<h1>Drinking Water Audit Report</h1>
---	--------------------------------------

County:	Clare County	Date of Audit:	07/08/2014
Plant(s) visited:	Ennistymon PWS 0300PUB1004	Date of issue of Audit Report:	08/09/2014
		File Reference:	DW2014/277
		Auditors:	Mr Niall Dunne
Audit Criteria:	<ul style="list-style-type: none"> • <i>The European Union (Drinking Water) Regulations 2014 (S.I. 122 of 2014).</i> • <i>The EPA Handbook on the Implementation of the Regulations for Water Services Authorities for Public Water Supplies (ISBN: 978-1-84095-349-7)</i> • <i>The recommendations specified in the EPA Report on <u>The Provision and Quality of Drinking Water in Ireland.</u></i> • <i>The recommendations in any previous audit reports.</i>

Photograph 1: Ferric dosing point submerged.

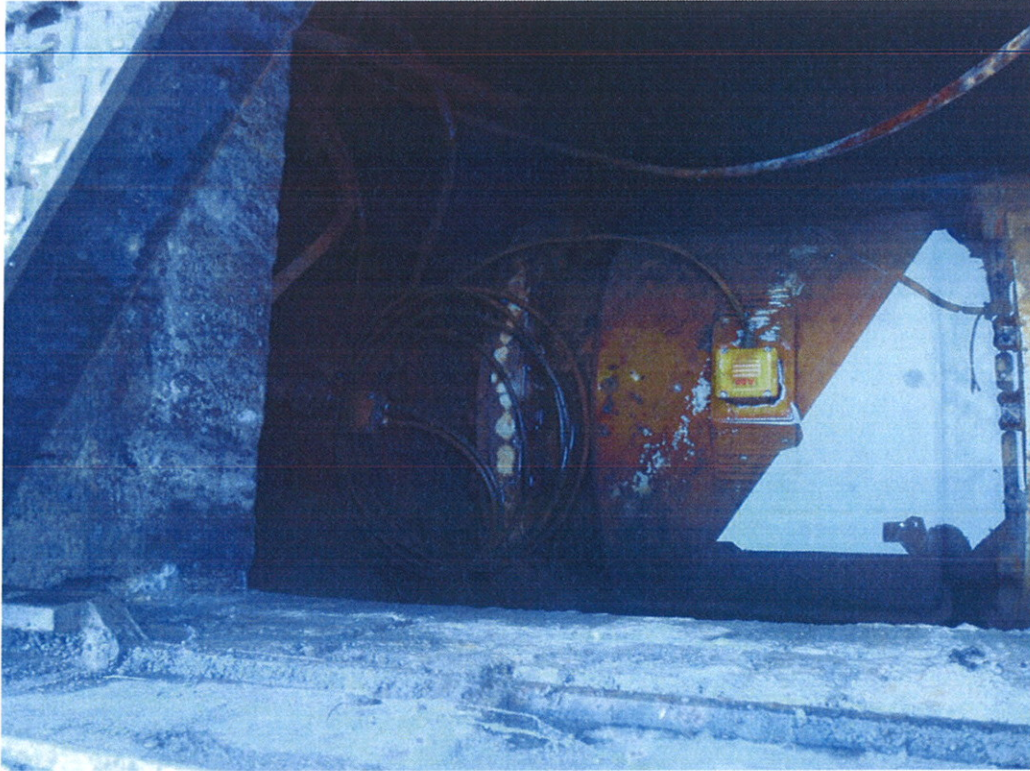
2.	<p>Coagulation, Flocculation and Clarification</p> <ul style="list-style-type: none"> a. According to CCC the plant was designed for 4,800 m³/day and is currently producing 6,000 - 7,500 m³/day. Flow through the plant is set at 300 m³/hr. b. The ferric dosing point chamber was observed to be full of water; (see photograph 1), ferric is dosed flow proportionally. Poly is dosed at approximately 0.17 mg/l; the dose is manually set. c. CCC were not aware of the contact time within the mixing chamber; but stated that there were baffles within the chamber to assist with mixing of the poly and the coagulant. d. Lime is dosed automatically based on pH. e. The walls of the clarifier were observed not to be clean. The decanting channels were observed to be clean and in good condition; but the main channel was showing signs of rust; (see photograph 2). f. CCC stated that Chemifloc under take jar tests approximately twice a year off site; and that no jar tests are done on site. g. Sludge bleeds are on a timer and are set for every 6-8 minutes; each bleed lasts for approximately 1-2 minutes. A bleed was observed to run clear. Sludge bleed run offs are sent to a picket fence thickener; to a centrifuge and then to land fill.

15. The Water Services Authority should carry out an integrity assessment of the ferric bulk storage tank.
16. The Water Services Authority should ensure that the water is removed from the ferric dosing chamber so that the dosing points can be inspected.

Photograph 3: Mudballing and cracking in the filter.

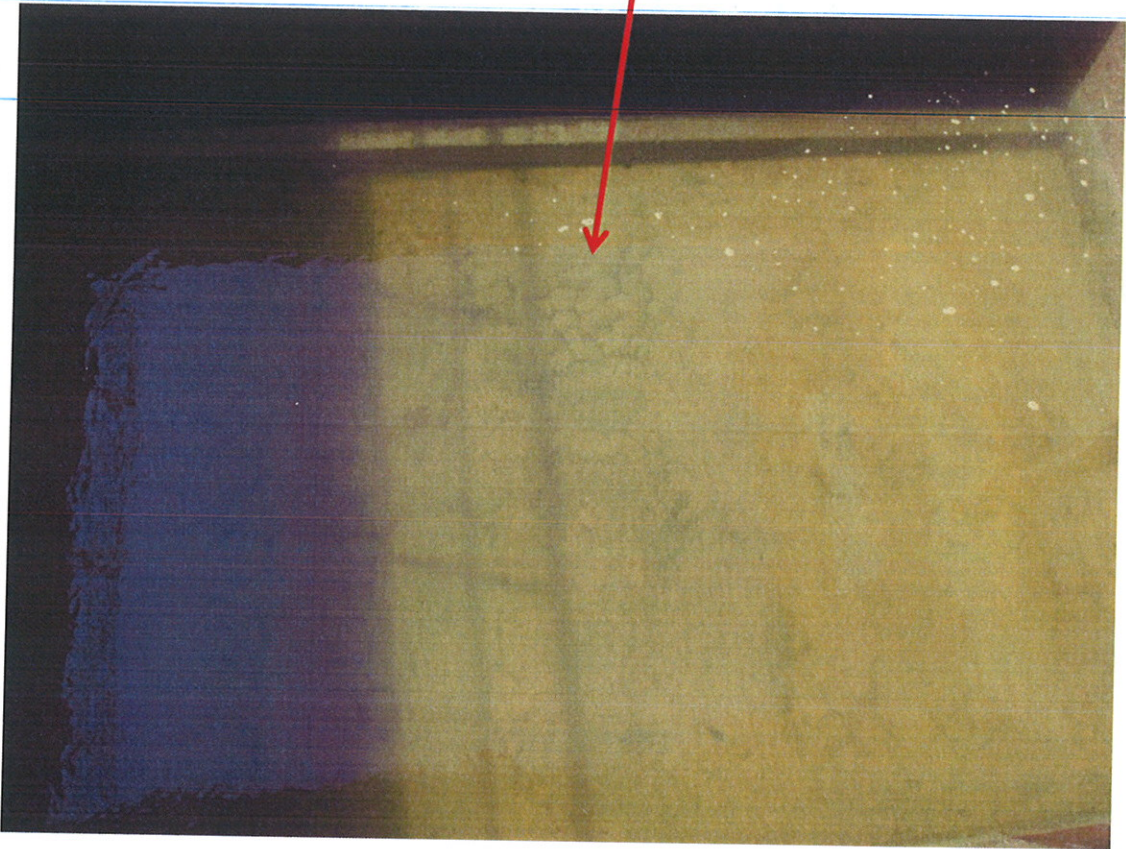
<ul style="list-style-type: none"> d. Mudballing and cracking was observed in the filter; (see photograph 3). e. The backwash cycle appeared to be even across the filter. f. Some sand was observed within the filter channel. g. The length of the backwash cycle is determined by visual observations and is not based on turbidity. Turbidity readings are not taken following the cycle and the monitors are not connected to SCADA and are not linked to a dial out alarm. The turbidity reading on the filter following backwashing was observed by the auditor to be 0.3 NTU. h. The turbidity readings on the other filters were observed to be 4.16 and 0.01 NTU, i. CCC stated that the filters following backwash are brought back into service with a slow start. j. The walls of the filter were observed to be stained and did not appear to be recently washed. k. Wash water from the filters is sent to a settling chamber; decanted water is sent to river and sludge is sent to landfill.

11. The Water Services Authority should investigate the cause of the mud balling /cracks in the filter media and should take appropriate action to optimise the operation of the filter and should review the operation and condition of the sand filter and ensure that any of the abnormal operating conditions (as outlined on pages 43 to 45 of the EPA publication "*Water Treatment Manual on Filtration*") are urgently rectified.

Photograph 4: Cover on ferric bulk tank not sealed and showing signs of spillage.

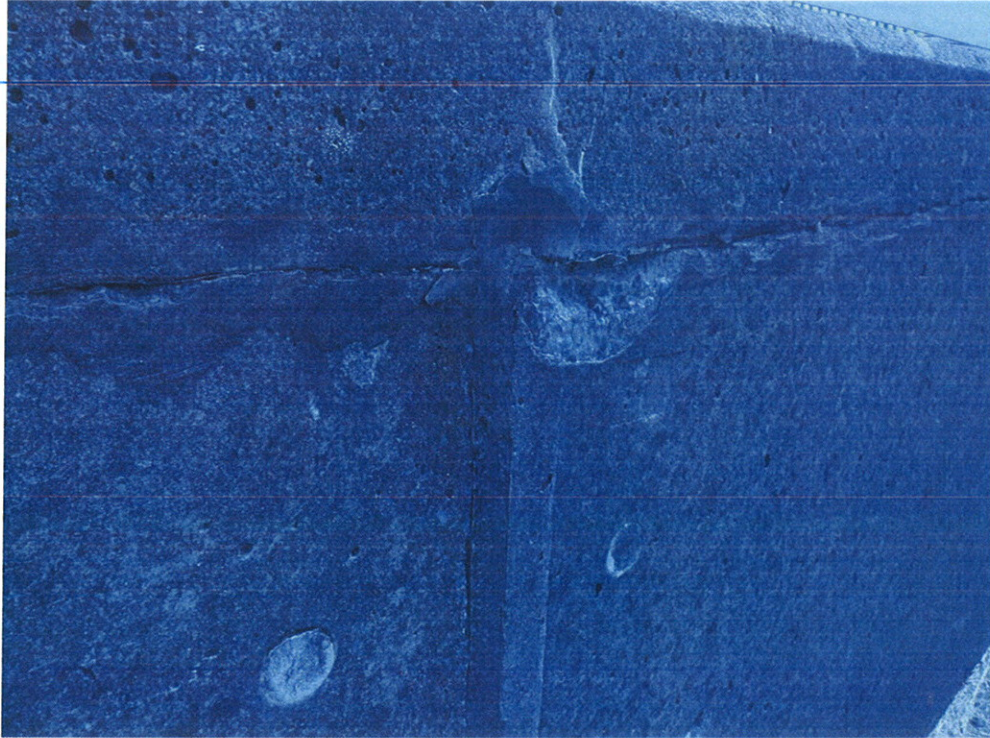
7.	<p>Chemical storage and bunds</p> <ul style="list-style-type: none"> a. Covers on the ferric bulk storage tank were observed not to be sealed properly and staining was observed around the cover; (see photograph 4). b. Cracks were observed in the ferric storage tank; (see photograph 5). There was no spill tray or lock observed on the ferric delivery point; (see photograph 6).
